MEMORANDUM FOR: File WM-39
THRU: Hubert J. Miller, Section Leader
Uranium Recovery Licensing Branch *WJM*
FROM: George Wu
Uranium Recovery Licensing Branch
SUBJECT: MEETING WITH DOE ON REMEDIAL ACTION PROGRAM

Meeting Minutes

NRC PARTICIPATION IN
TITLE I - REMEDIAL ACTION PROGRAM

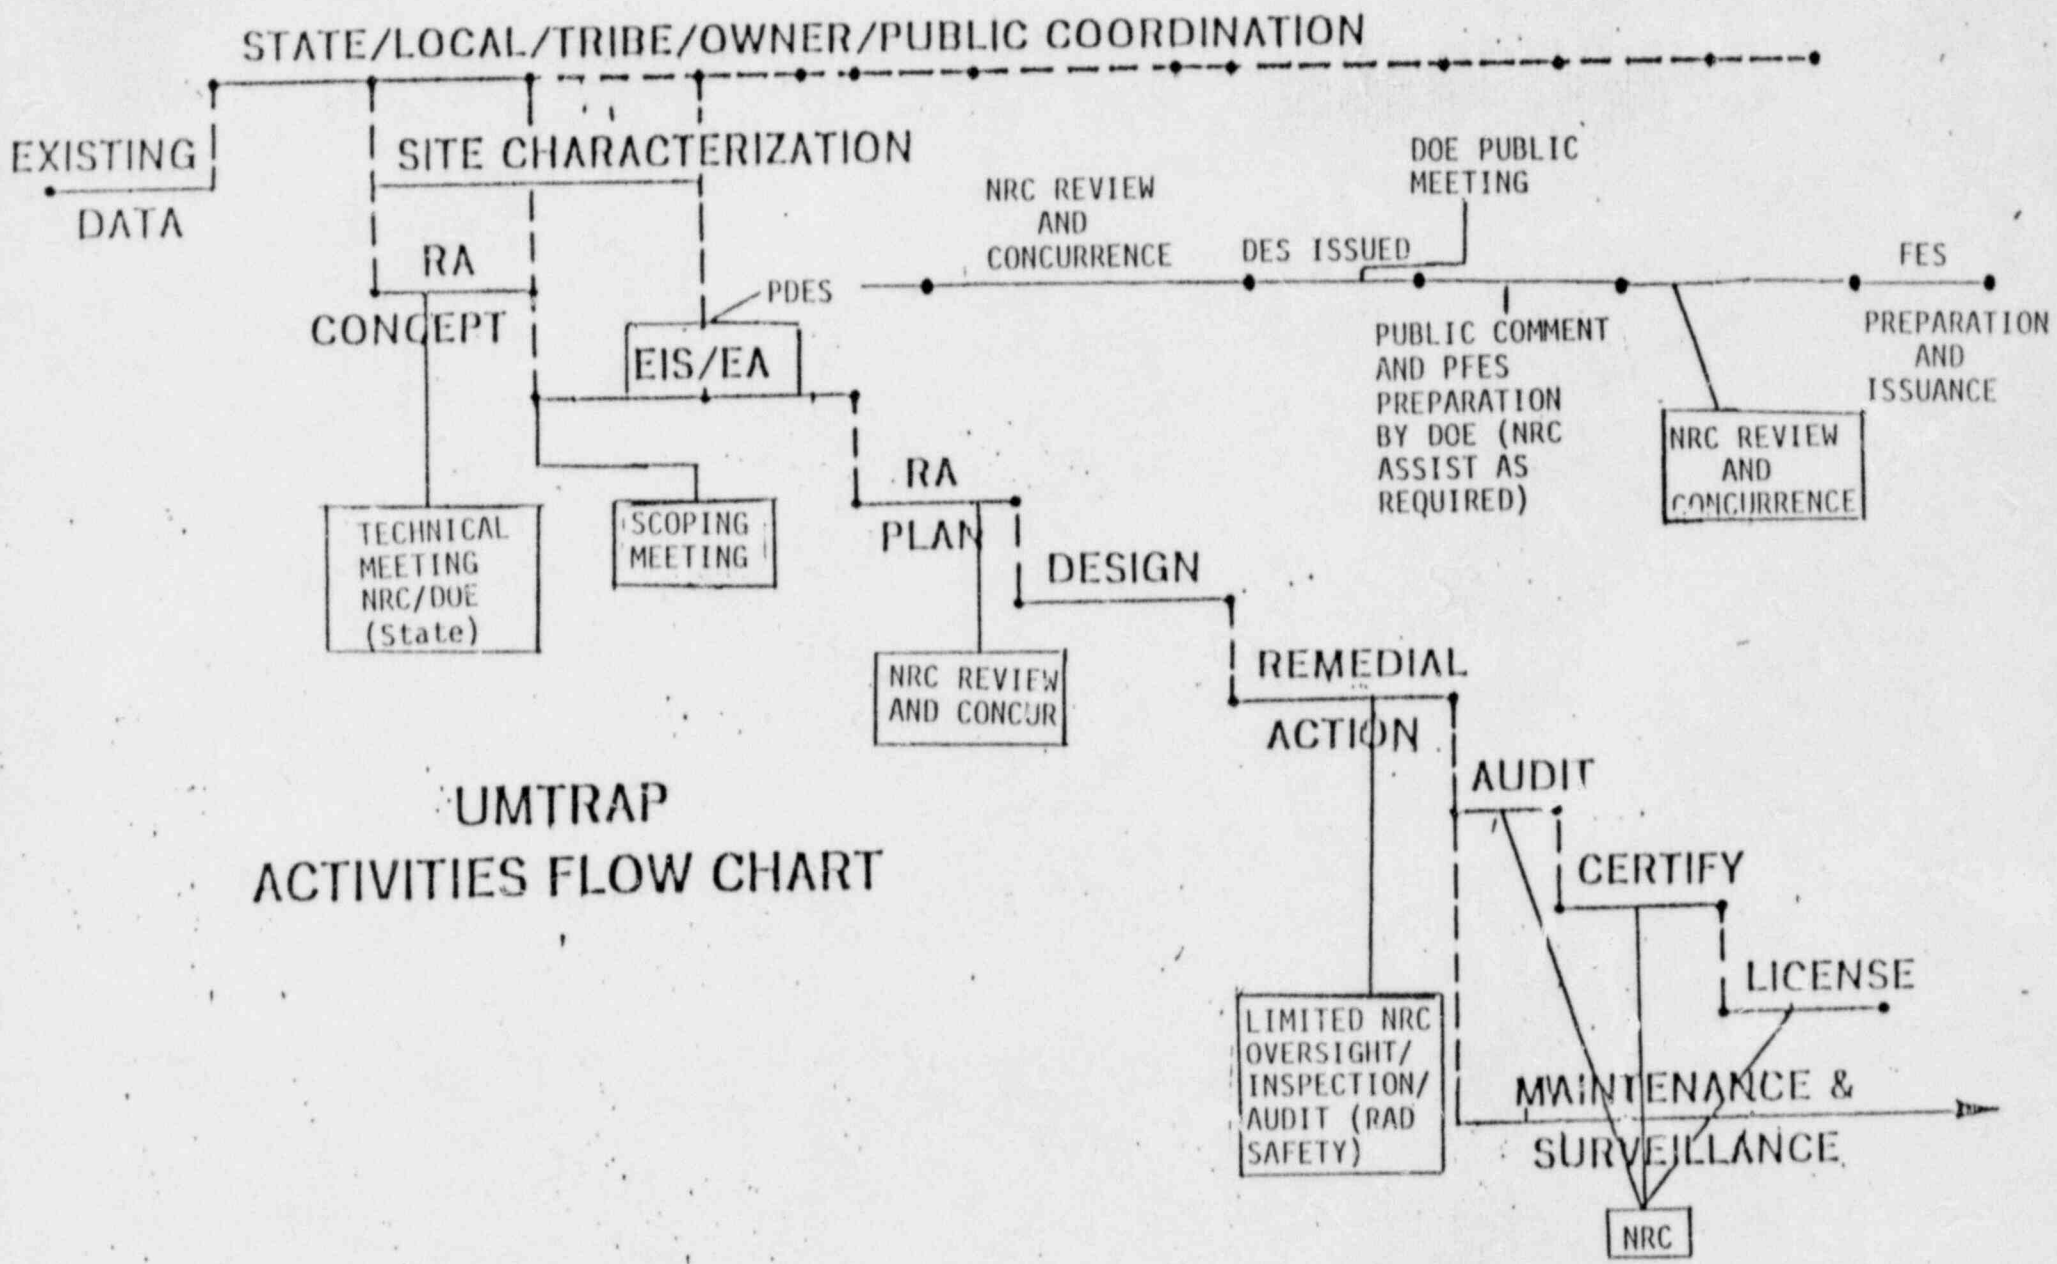
- Public Meetings in connection with NEPA-EIS process, if held.
3. Specific points of formal concurrence as currently known are marked up on the attached flow diagram (Enclosure 4).
